S90-09/10
1609.1.2.2, Chapter 35

Proposed Change as Submitted

Proponent: John Woestman, The Kellen Company, representing the Door Safety Council (DSC)

FIGURE 1613.5(2)
MAXIMUM CONSIDERED EARTHQUAKE (MCE) GROUND MOTION OF 1 S SPECTRAL RESPONSE
ACCELERATION (5% OF CRITICAL DAMPING), SITE CLASS B

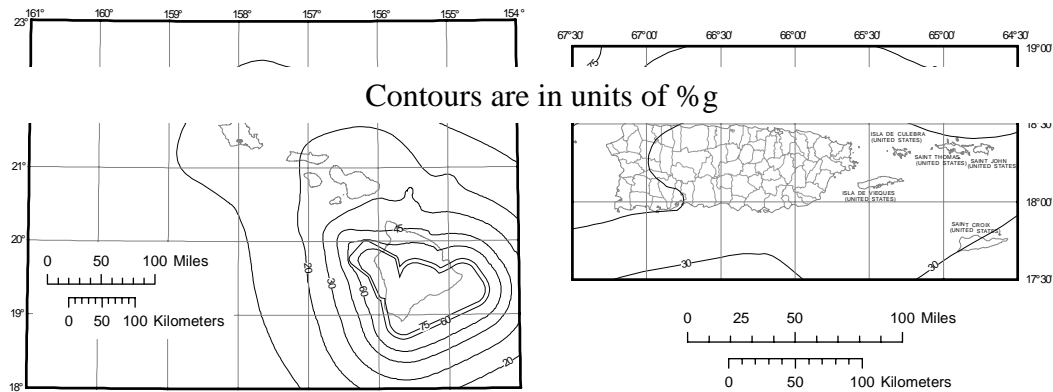
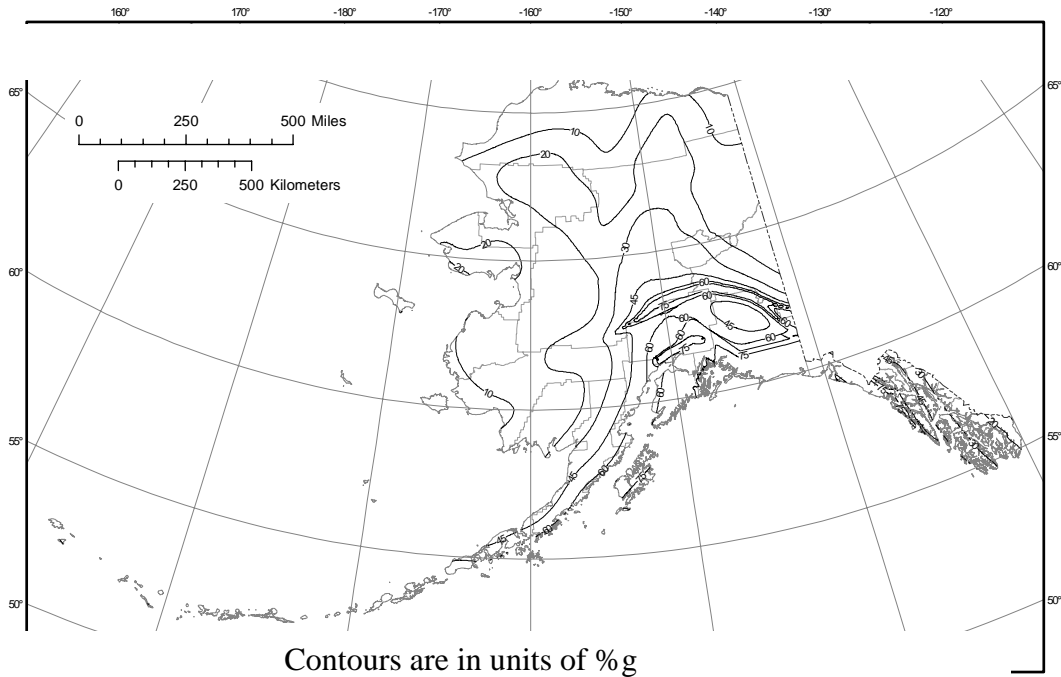
The proposed ground motion maps for the IBC also reflect a current draft proposal for change to the ASCE 7 (Minimum Design Loads for Buildings and other Structures) standard update process. Under normal circumstances, ASCE 7 would adopt ground motion map related changes drawn from the most current edition of the *NEHRP Recommended Seismic Provisions* prior to incorporation of the maps into the IBC; however, the recent changes to the ICC code development process and schedule have made it necessary to submit this working version of the ASCE 7 proposal in an effort to provide the regulatory community with the most up-to-date information available. It should be understood that, to the extent possible, this proposal will be updated to reflect any modifications to maps, maps titles or other Section 1613 content made during the ASCE 7 consensus standard process so the consistency between ASCE 7 and the IBC is maintained. In the NEHRP update process the title for these maps was revised from "Maximum Considered Earthquake (MCE) Ground Motions" to "Risk-Targeted Earthquake (RTE) Ground Motions." This proposal retains the MCE terminology because it is retained in the working version of the ASCE 7 proposal.

This proposal also reduces the number of printed maps to appear in the IBC from 14 to 2. Twelve of the maps included in earlier editions of the IBC provided enlargements of portions of two maps that covered the entire United States; this proposal eliminates the enlargements. This is being recommended because the maps printed in former editions of the IBC, while generally illustrative of the earthquake hazard, could not be read clearly enough to provide exact design values for specific building sites. Those in need of precise design values can easily obtain them from a USGS web site (<http://earthquake.usgs.gov/research/hazmaps/design/index.php>) using the longitude and latitude of the building site, obtained from GPS mapping programs or web sites.

- (b) inclusive of *changes* in Mapped Spectral Response Acceleration contour values from previous code editions that were *not* specifically made clear (along with the impact of those changes on seismic design parameters).

- (c) inclusive of changes resulting from applying Next Generation Attenuation (NGA) relationships that reduced design spectral response acceleration by up to 25% in some earthquake prone regions of the country, despite a clear lack of consensus for this change from the USGS Ground Motion Mapping Workshop participants.

For the wholesale changes proposed here (where seismic hazard has become whatever input parameters people can come up with . . . from NGA, GPS strain monitoring, new faults and so-called slip rates, Risk mumbo-jumbo, generic fragility curves); the new spectral response acceleration maps should have first been produced in the same manner as the previous code editions - then a comparison of results could have been made with proposed applications of the new map. This is necessary for a reality check as to the reasonableness of adopting something “new” for “newness” sake, where it might weaken or reduce long accepted minimum standards for protecting the public safety.

These new maps should have provided a city-by-city comparison of old map design values with the “latest” to be considered values. Otherwise, there is no telling how the public safety is being impacted. Documentation of the discussions, votes taken, and specific explanations and justifications for these changes should have been provided to the committee and to the public. A code change proponent must be held accountable to justify these changes (and also clearly define these same) to the committee from which approval is sought. Giving a weblink to a telephone book of information is unacceptable for a public process.

Committee Reason: This proposal incorporates the latest USGS ground motion maps. The modification updates the map titles and provides reformatted versions of the maps with no technical changes. It also separates areas outside the conterminous United States, on individual maps.

FIGURE 1613.5(1)

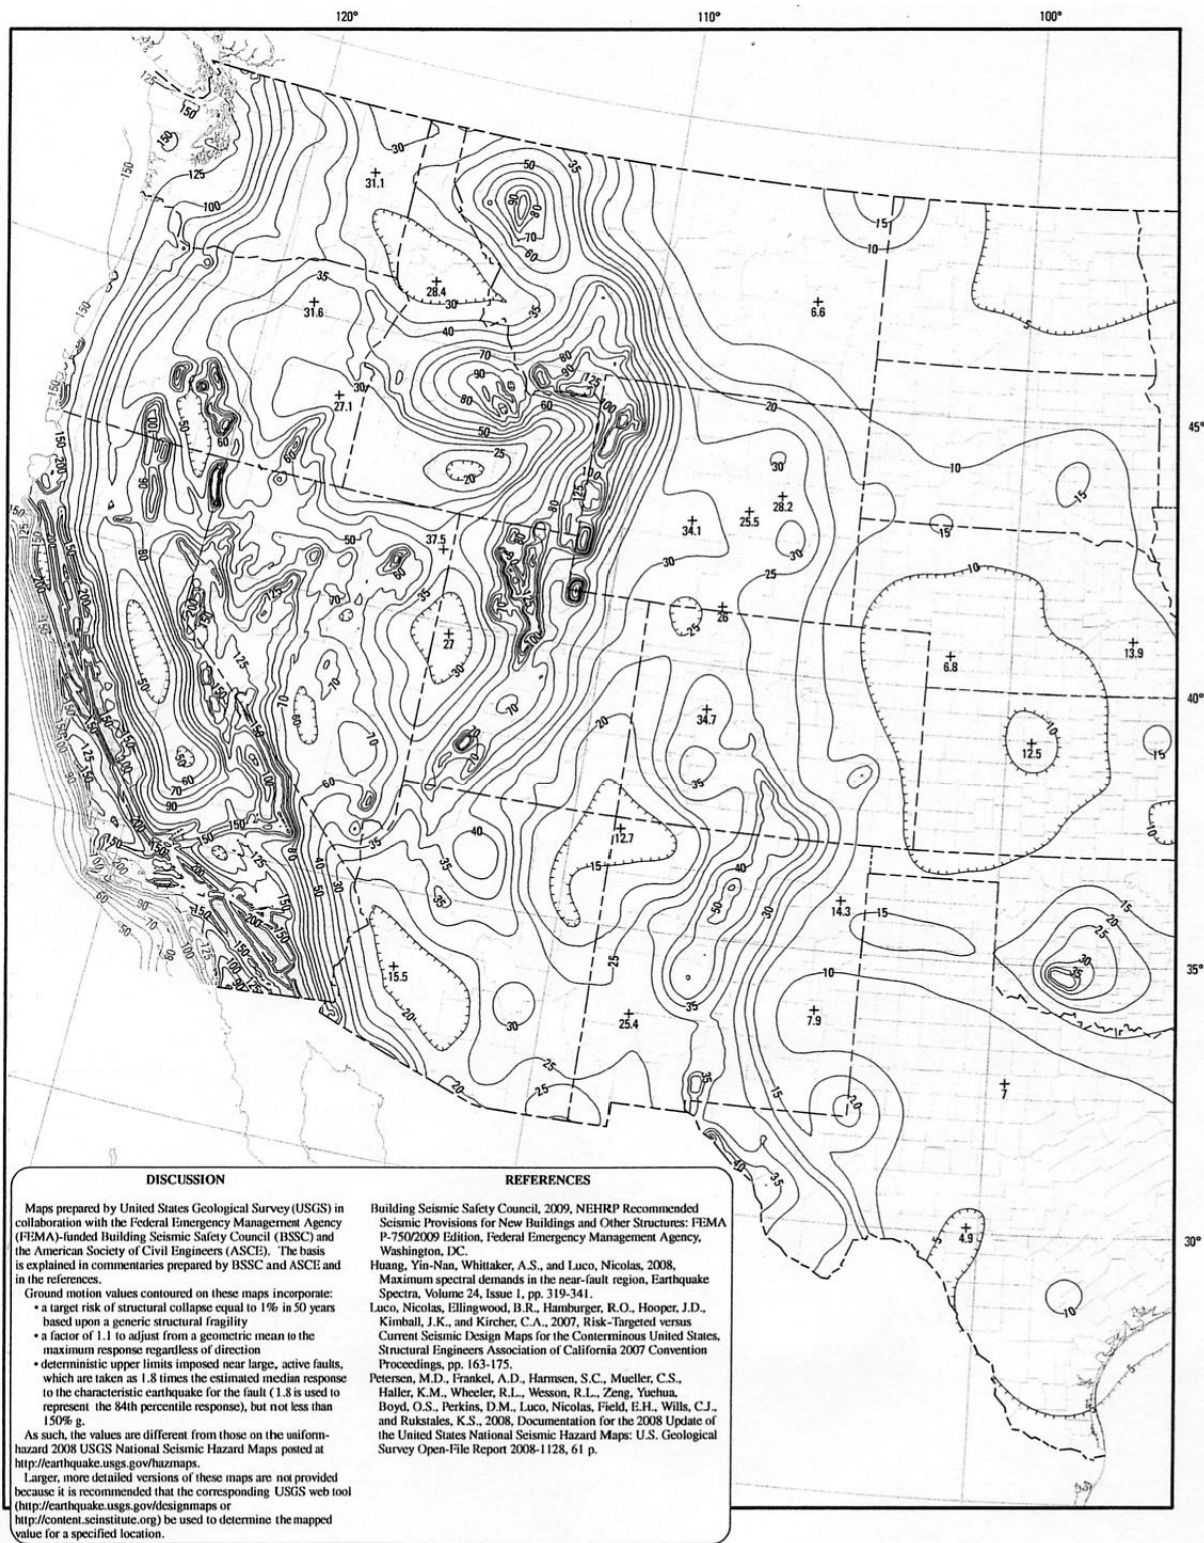
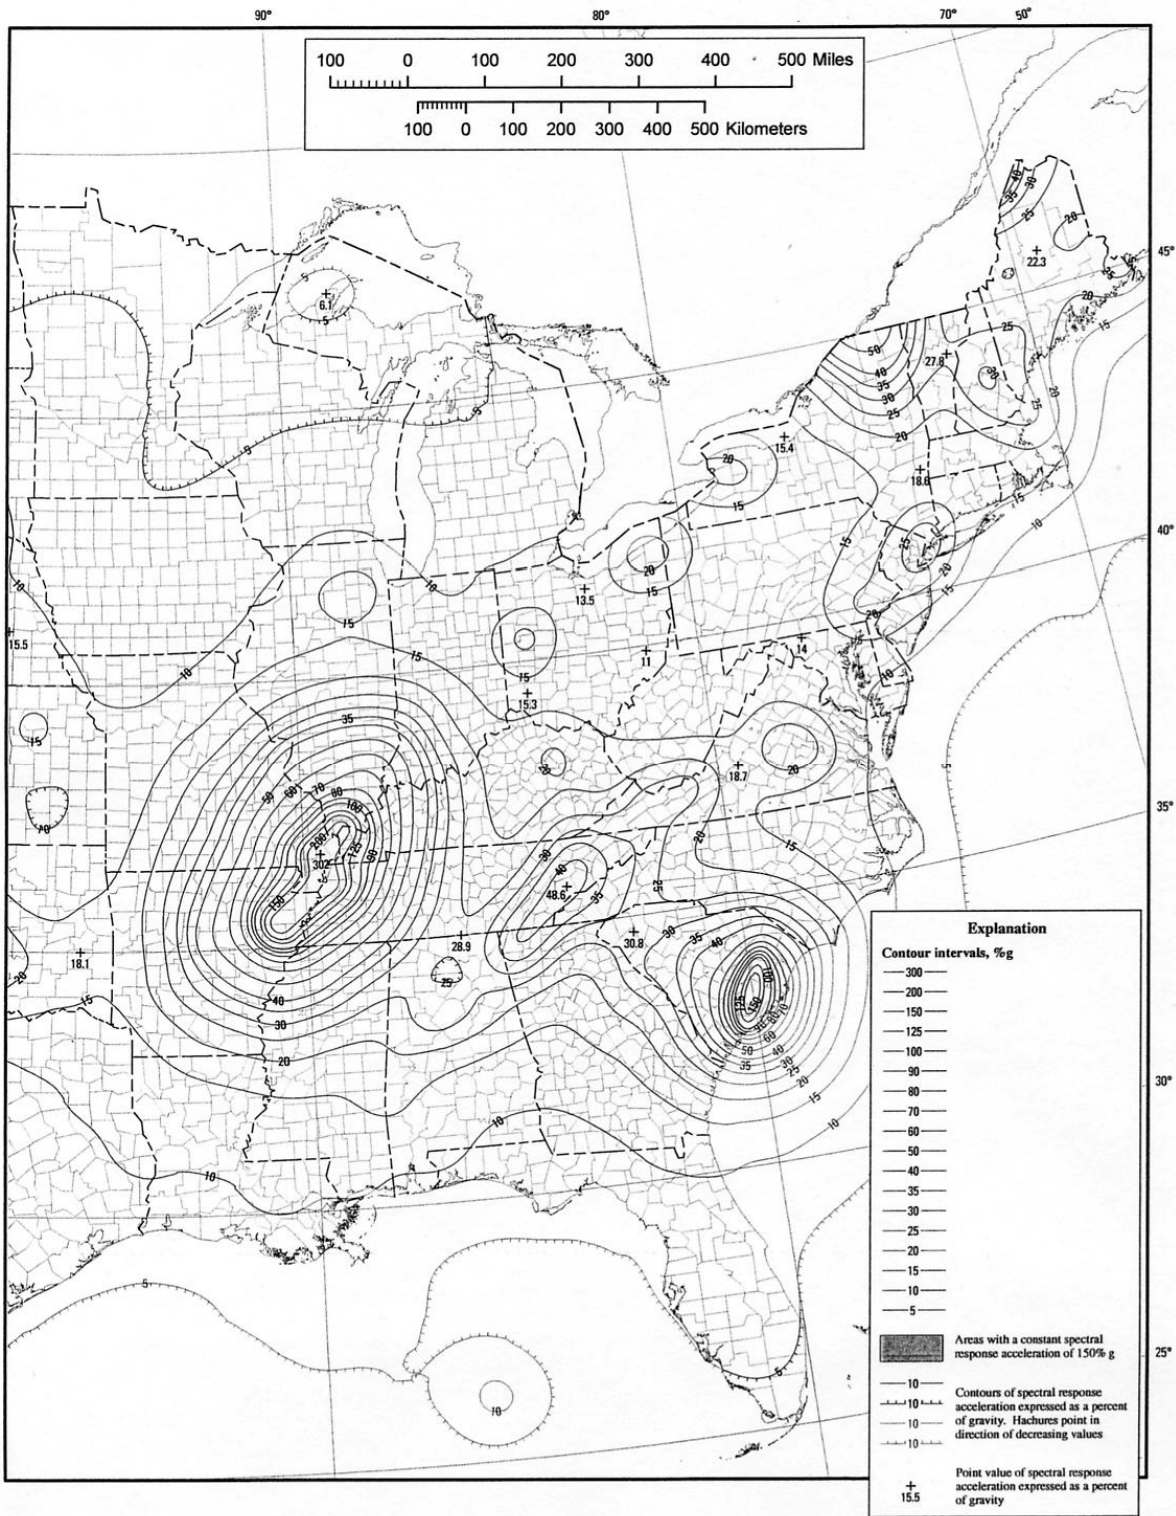
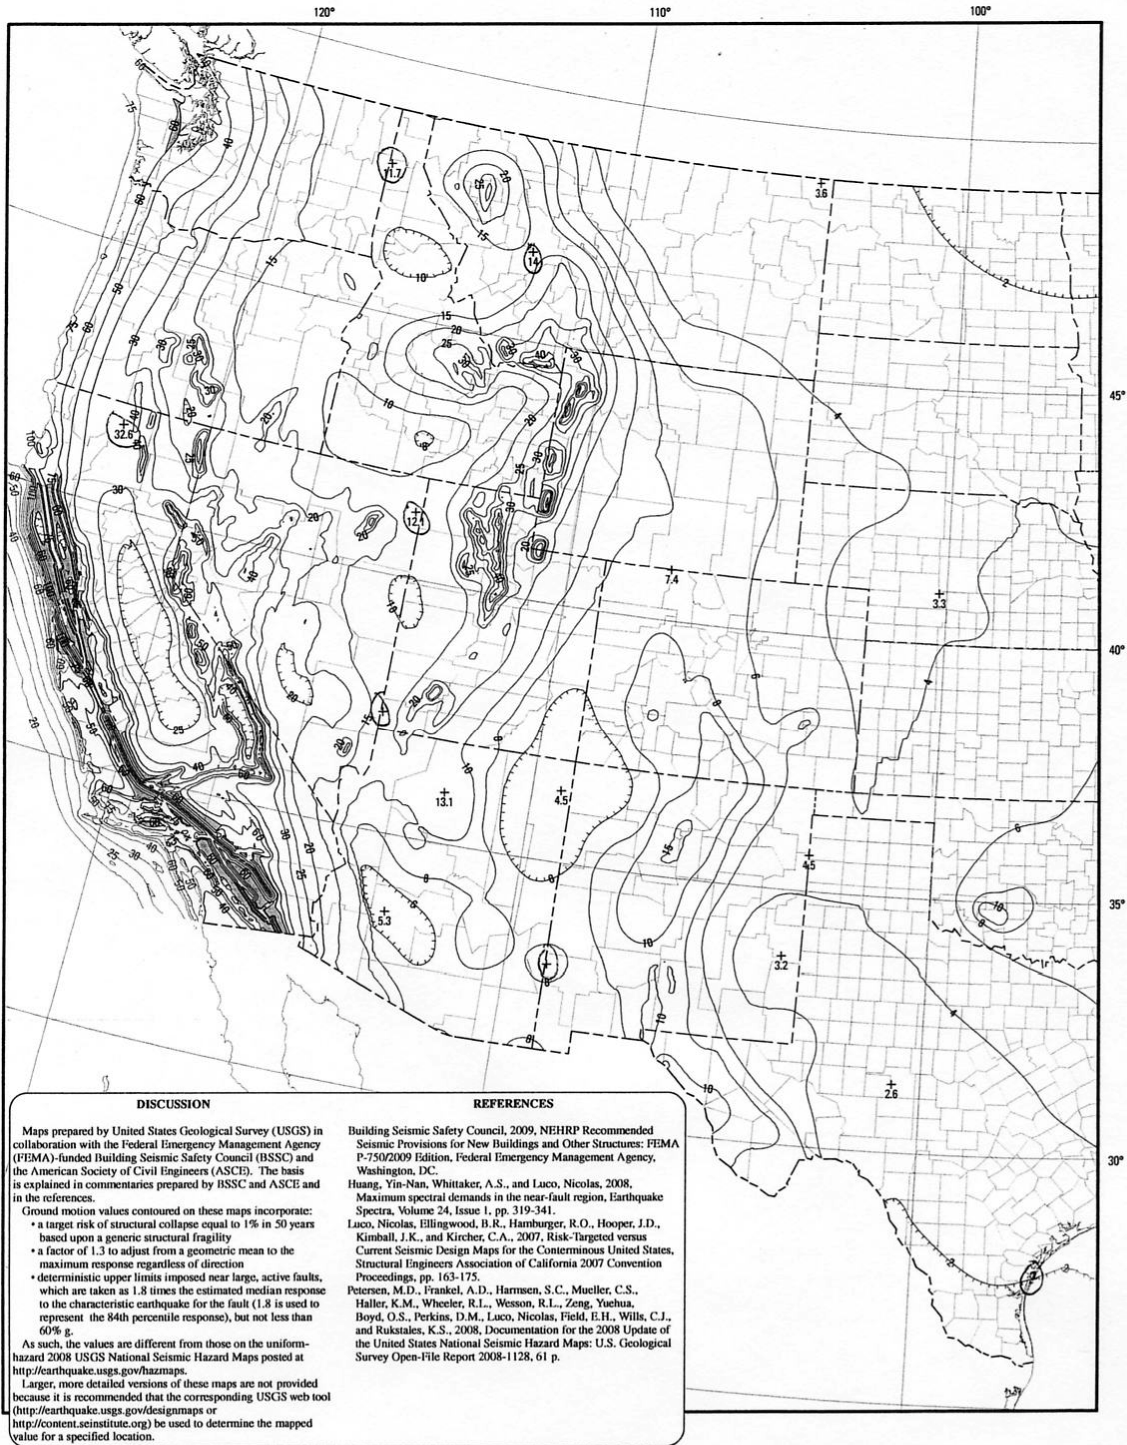
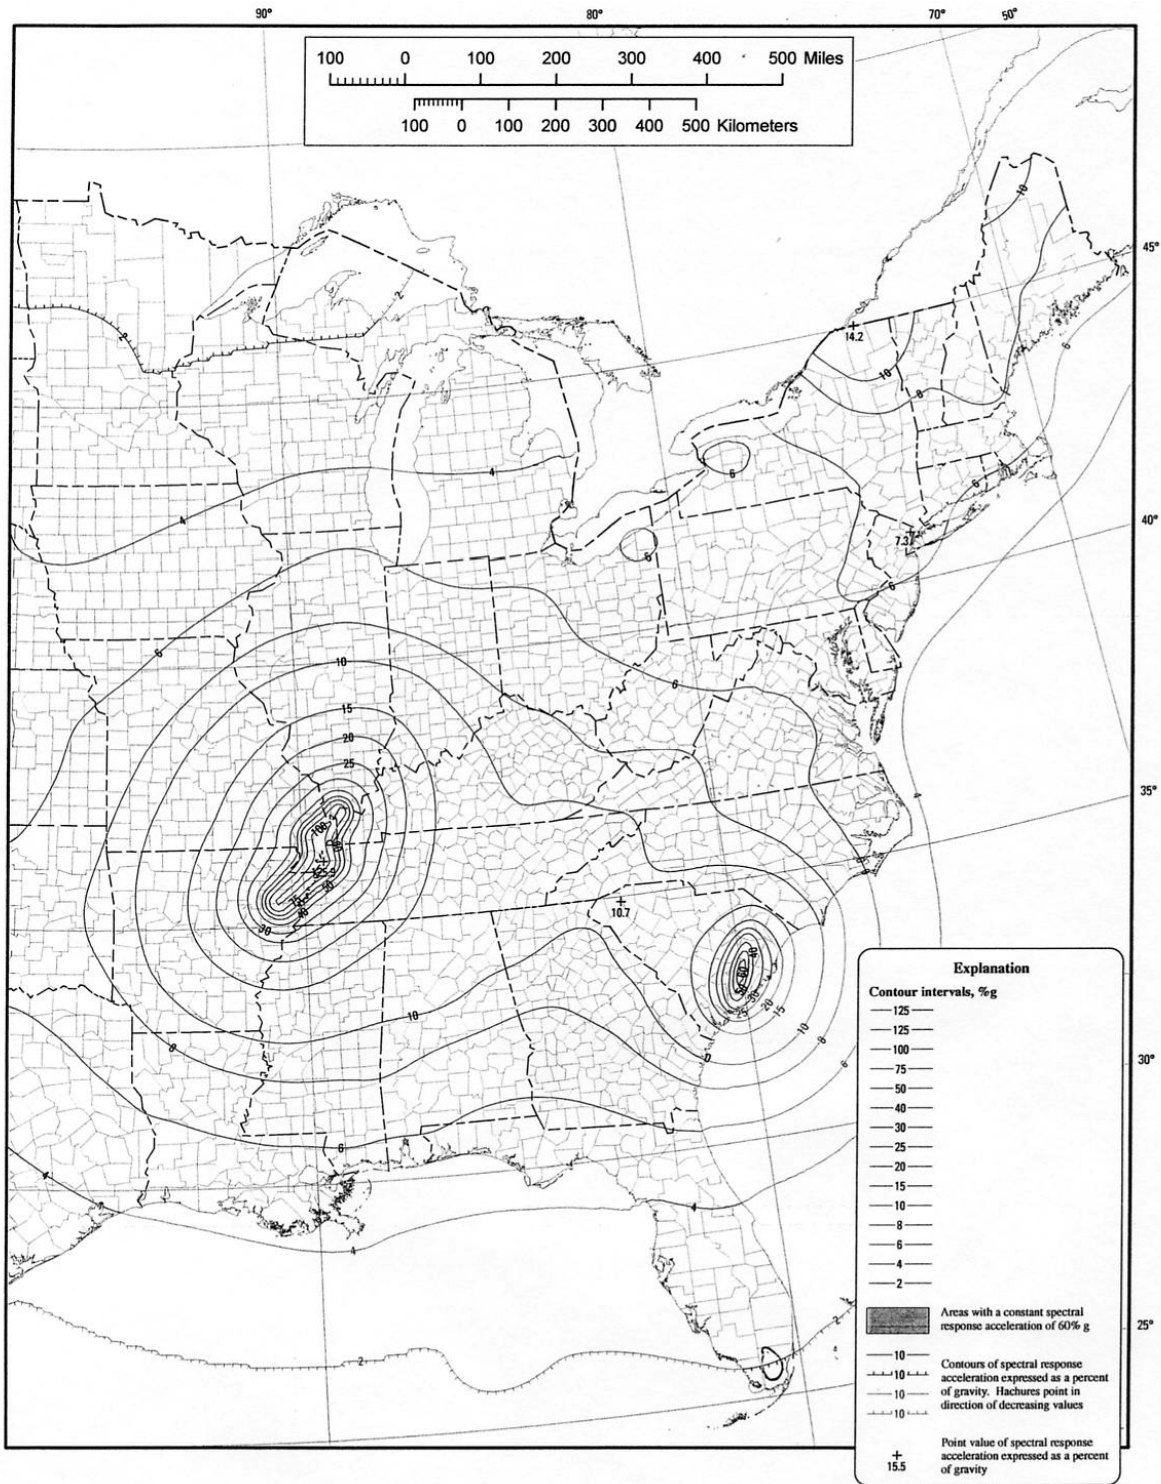
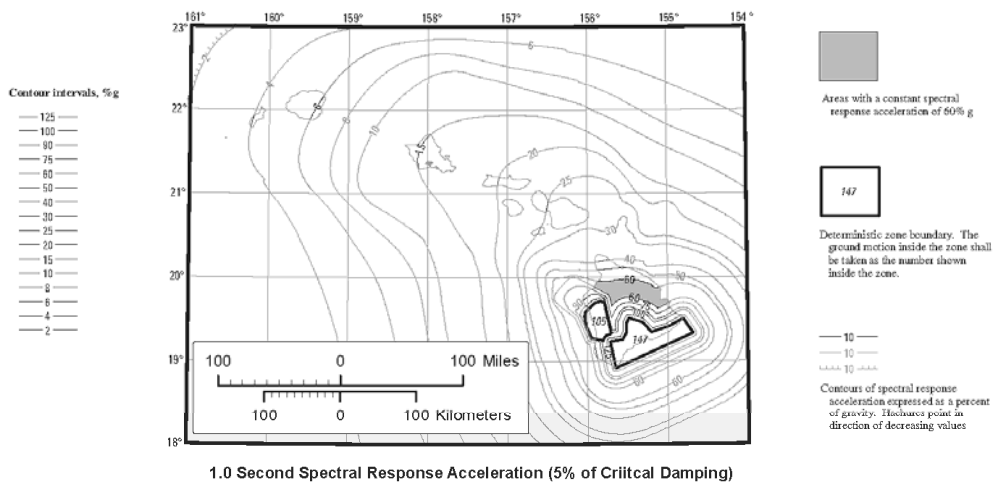
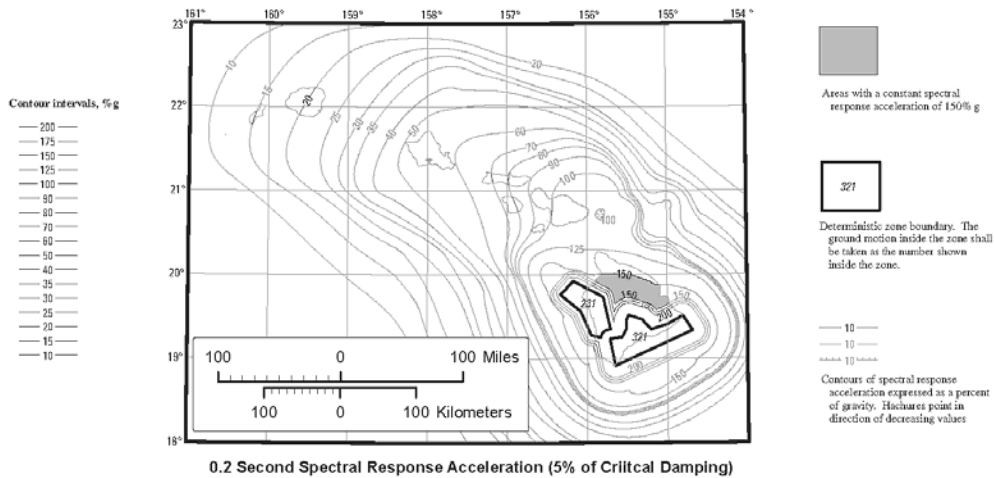
Commenter's Reason: In the original submittal, the reason stated that this code change would be modified if required to correlate with modifications to the maps being adopted into ASCE 7. This modification changes the map titles and definition to coordinate with ASCE 7 wording. This change is editorial; there is no technical change.

RISK-TARGETED MAXIMUM CONSIDERED EARTHQUAKE (MCE_R) GROUND MOTION RESPONSE ACCELERATIONS (MCE_R) FOR THE CONTERMINOUS UNITED STATES OF 0.2 SECOND SPECTRAL RESPONSE ACCELERATION (5% OF CRITICAL DAMPING), SITE CLASS B

RISK-TARGETED MAXIMUM CONSIDERED EARTHQUAKE (MCE_R) GROUND MOTION RESPONSE ACCELERATIONS (MCE_R) FOR THE CONTERMINOUS UNITED STATES OF 1 SECOND SPECTRAL RESPONSE ACCELERATION (5% OF CRITICAL DAMPING), SITE CLASS B
